**TO:** MASTER PLAN AND ZONING COMMITTEE  
**FROM:** SRI RAVALI KOMARAGIRI, PLANNER  
**THRU:** BARBARA MCBETH, *AICP*, CITY PLANNER  
**SUBJECT:** CONSIDERATION OF PRO CONCEPT PLAN FOR NOVAPLEX  
**DATE:** SEPTEMBER 05, 2019

The petitioner, BC Novaplex LLC, is requesting a Zoning Map amendment for 22 acre property on the west side of Haggerty Road, north of Twelve Mile Road (Section 12) from Office Service Technology (OST) to High-Density Multiple Family (RM-2) with a Planned Rezoning Overlay. The applicant is proposing to develop a 332 unit multiple-family residential development. The development consists of two attached town style buildings and eight apartment style building. All units are three stories tall at its average grade. The development is a private street network with two entrances off of Haggerty Road.

Rezoning Request from OST Office Service Technology to High-Density Multiple Family RM-2 with a Planned Rezoning Overlay

**SIGN LOCATION PLAN**

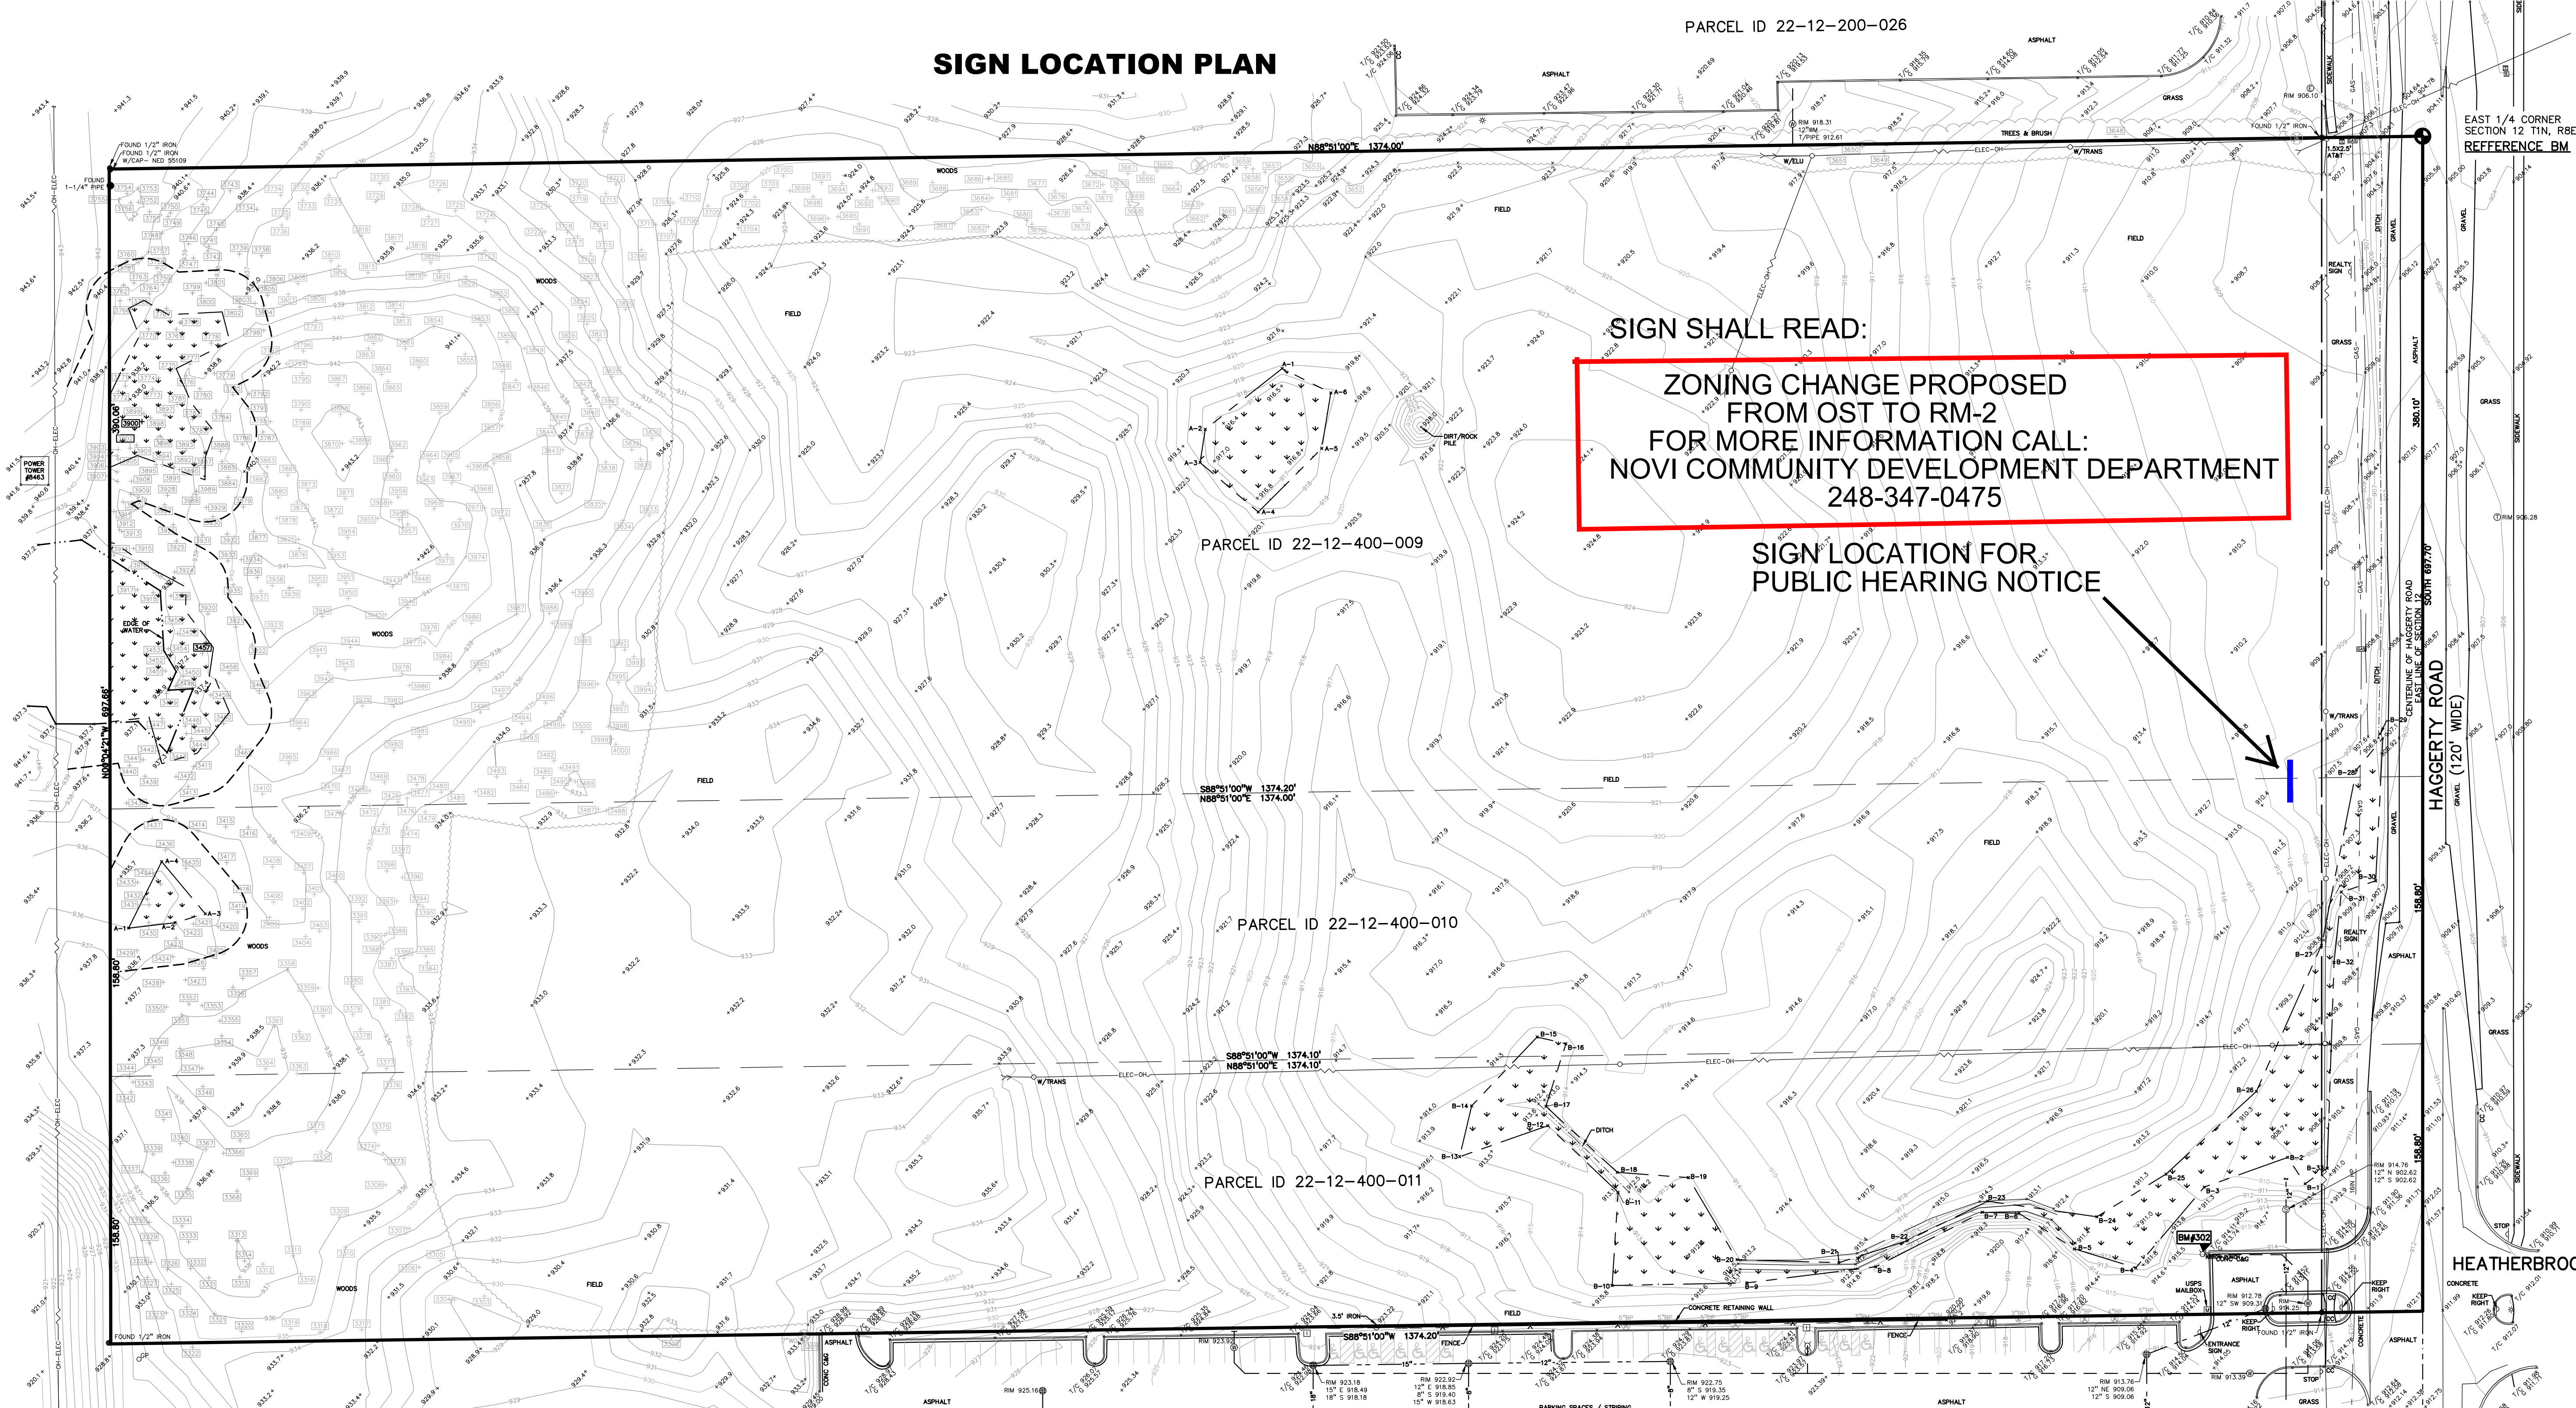
- d. **Sign Location Plan:** Please change ‘OST to RM-2’ to ‘OST to RM-2 with a PRO’. Location and other text are acceptable.
  - e. **Soil boring report:** This dates back to 1999. Refer to Engineering review for more details.
